Public Comment No. 14-NFPA 211-2022 [Global Input]

Public Comment No. 15-NFPA 211-2022 [Section No. 1.1]

Figure 11.2.5.4 Fireplace Clearance to Combustible Material.

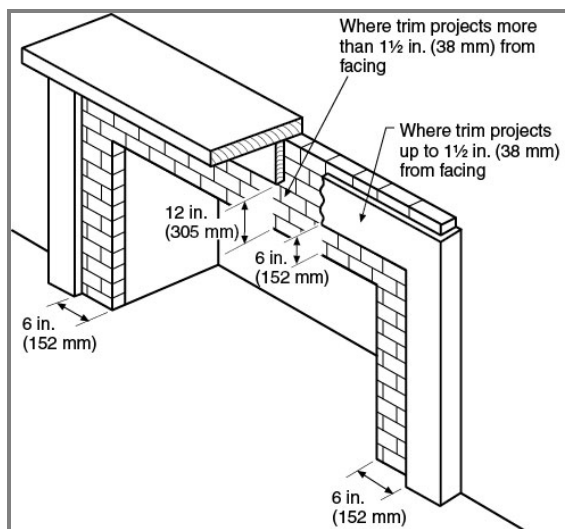
Combustible material ~~above and projecting~~ material projecting more than 1½ in. (38 mm) from a fireplace opening shall ~~off the facing of a fireplace shall~~ not be placed less than 12 in. (305 mm) from the top or sides of the fireplace opening. (See Figure 11.2.5.4.)

By adding this requirement for the sides of a fireplace opening, it will be more consistent with the International Residential Code/Building Code. The Standard 211 currently does not have language that prevents a 10" projection 7" from the sides of a fireplace opening. This addition would place a 10" projection or even a perpendicular combustible wall 12" from the sides of the opening.

Resolution: The proposed changes are new material for this code cycle and is being rejected but held for the next cycle.
